**LEBANON PLANNING BOARD
MAY 13, 2024 - 6:30 PM
COUNCIL CHAMBERS, CITY HALL OR
REMOTE VIA VIRTUAL PLATFORM
LEBANONNH.GOV/LIVE**

- A. **Dartmouth Hitchcock Medical Center, 1 Medical Center Drive (Tax Map 10, Lot 8), zoned MC:** Applicant requests a Site Plan amendment to expand and reconfigure four existing parking lots and to widen a driveway, together with associated site improvements. **PB2024-12-SPA**

RE: DHMC Main Campus Parking Expansion
City of Lebanon, New Hampshire
Planning & Zoning Review

On behalf of DHMC please find below written responses to comments provided by your office on the above referenced Site Plans Review application. All the comments are repeated below. The highlighted comments are the ones you asked us to specifically address. Our responses are provided in red.

C002
Page 3 of 27

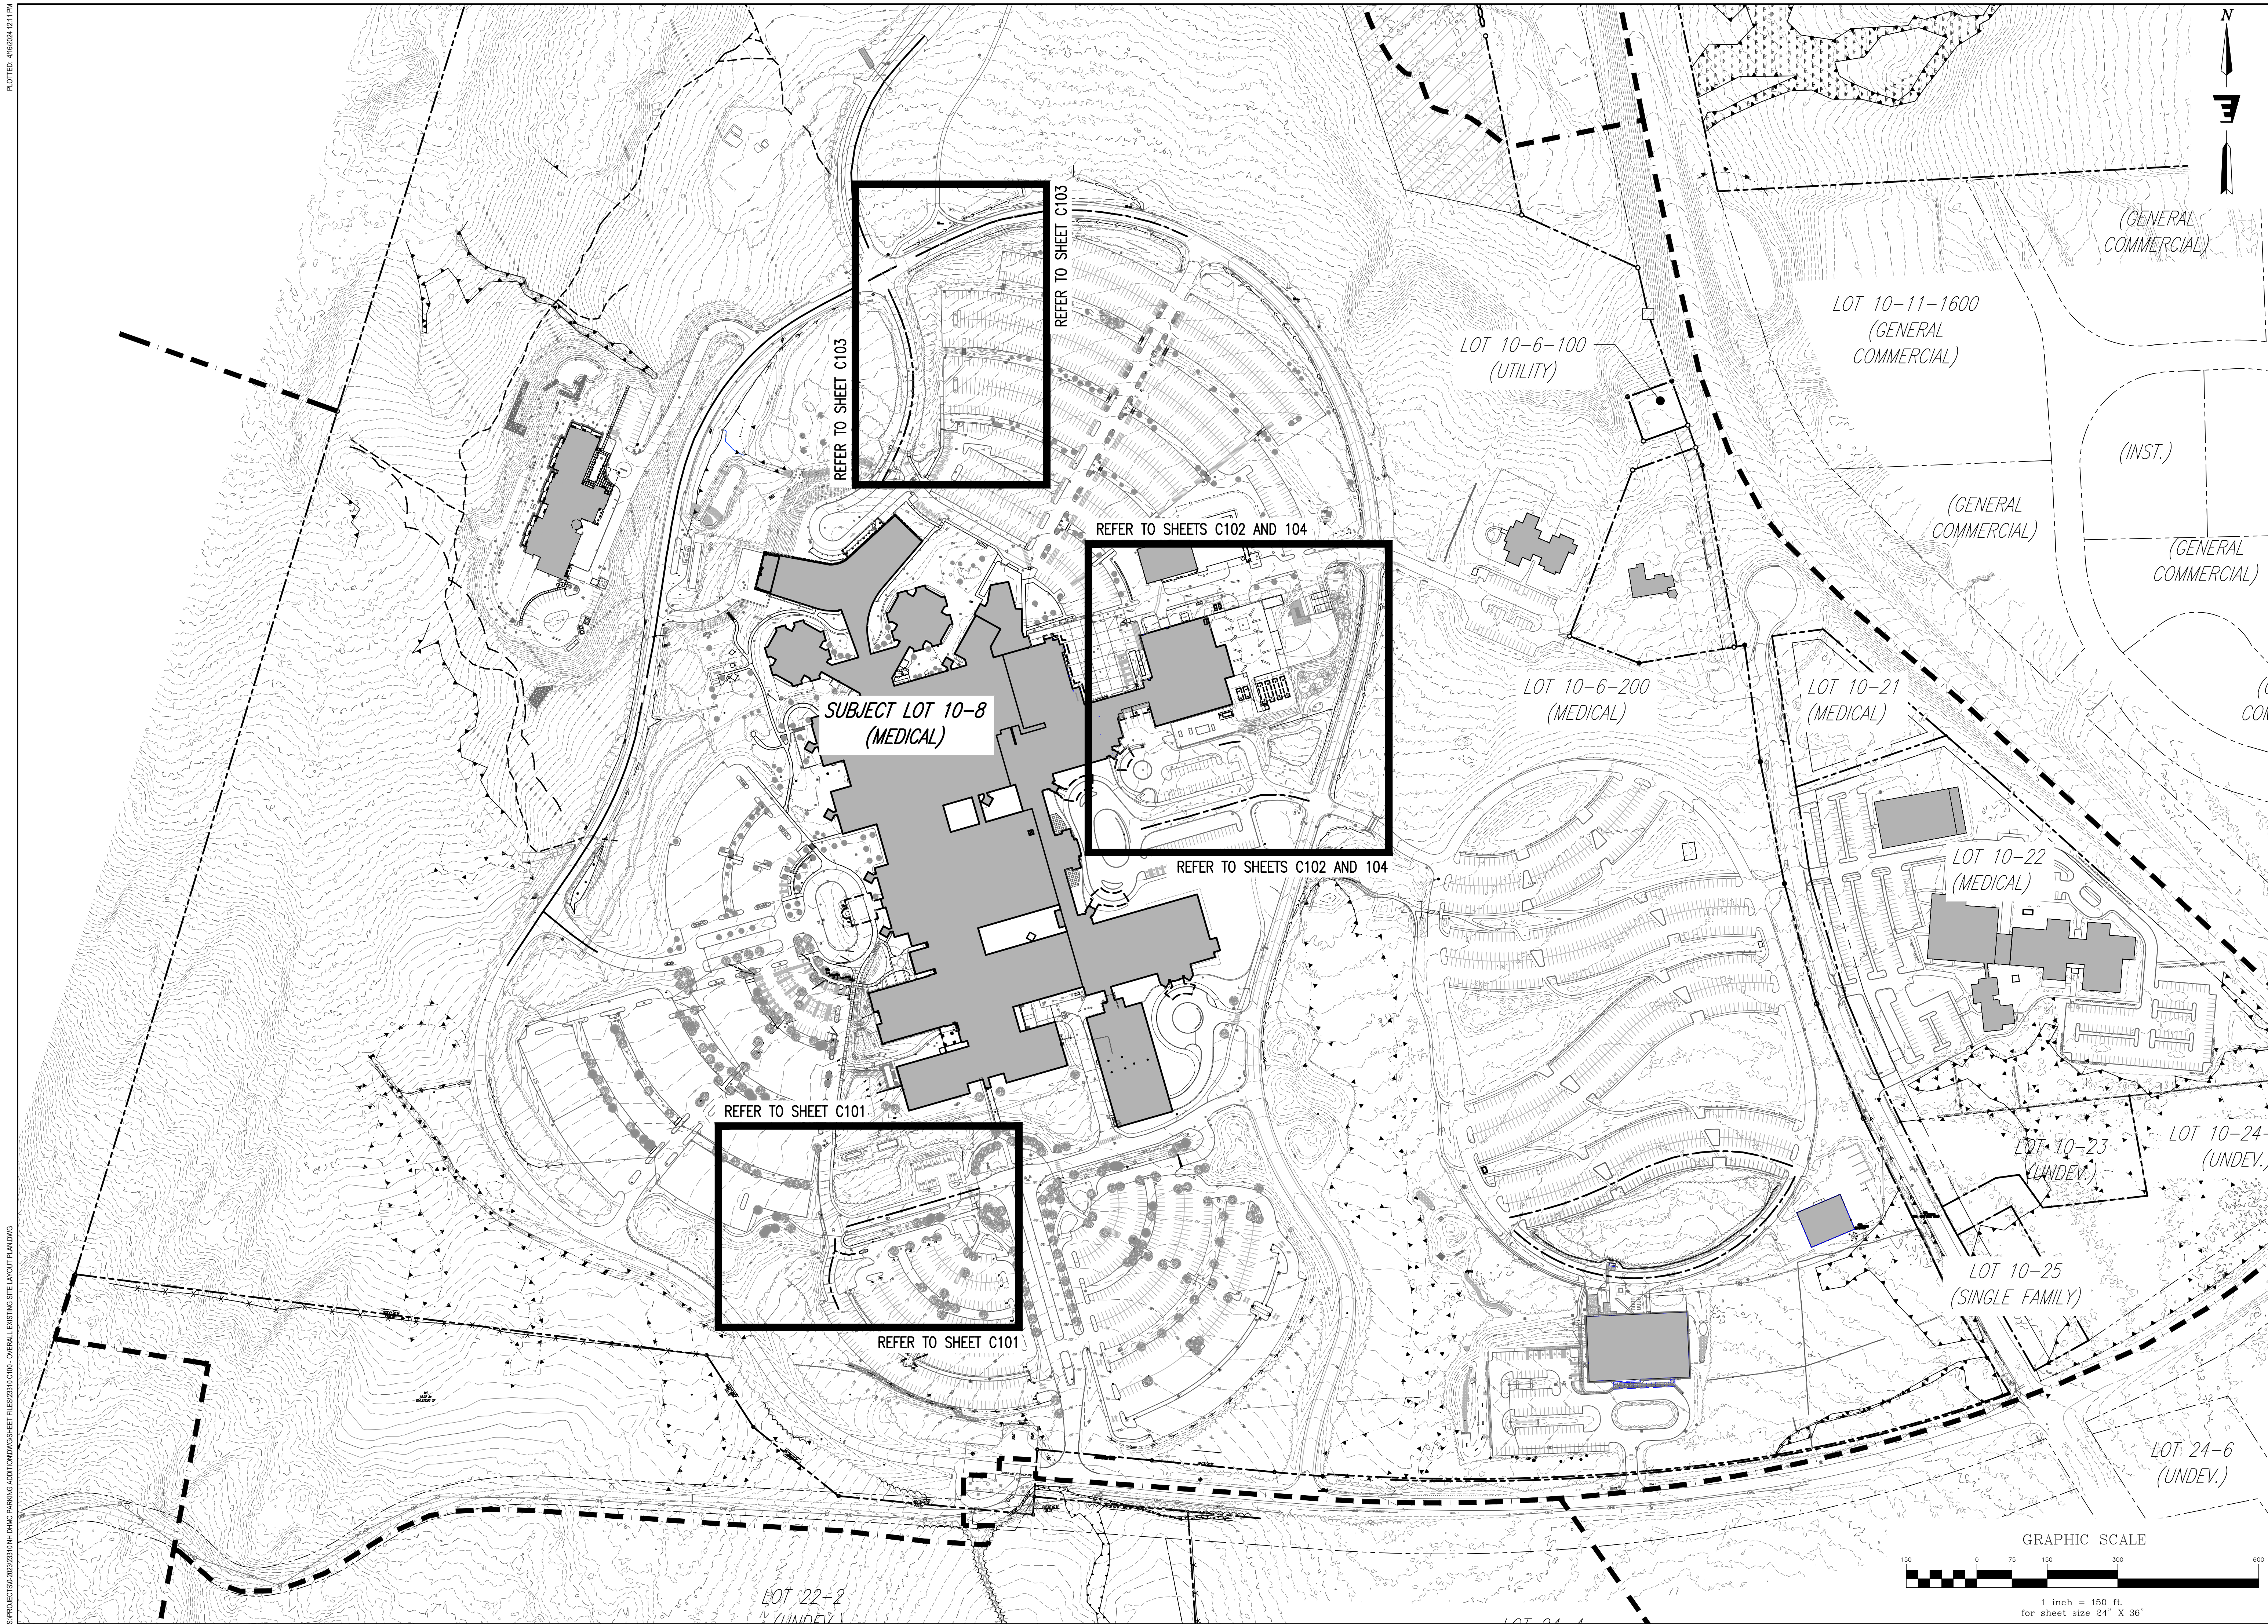
- Sheet 3 (C002)
 - Is abutter’s list up to date?
 - The abutter’s list has been verified and revised as needed.

- The revised Zoning Table now includes setback distances in the "Existing" and "Proposed Total" columns. Setbacks area also dimensioned on sheet C002.

C104
 Page 8 of 27

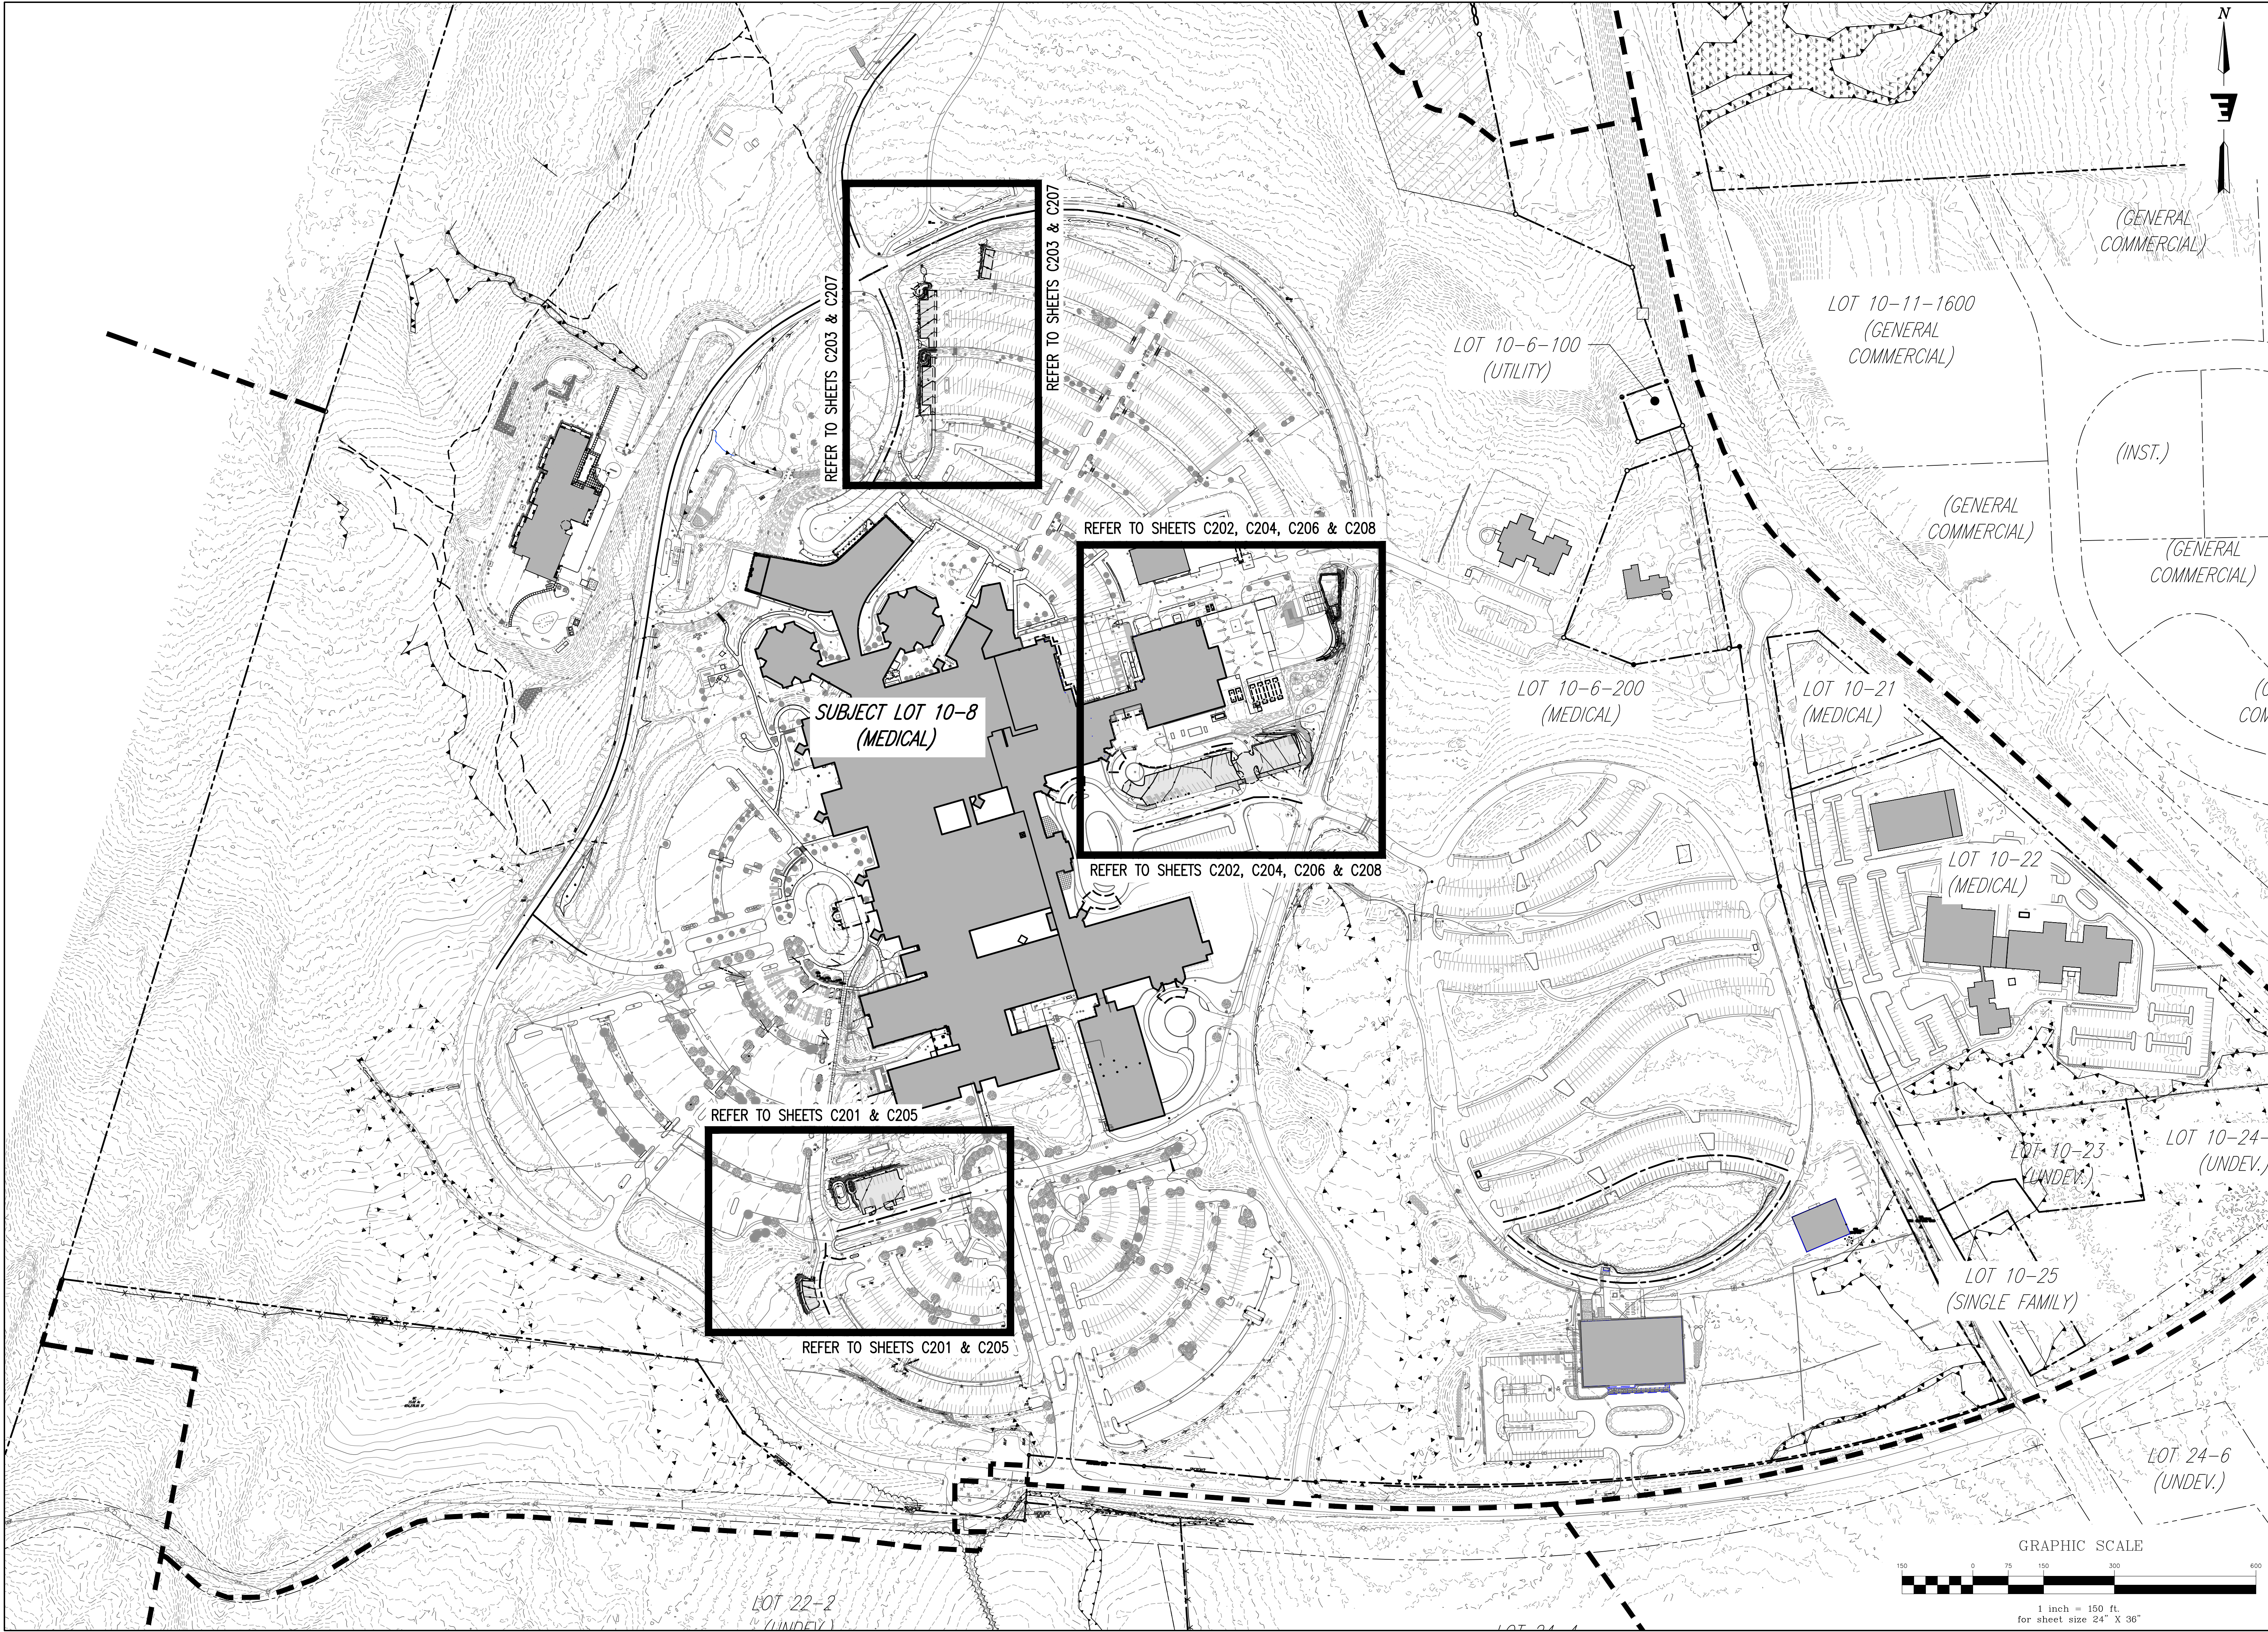
- Demo items have been added to existing conditions plans; sheets C101-C104
- **Sheet 8 (C104) is mislabeled along the bottom of the sheet as "SITE PLAN"**
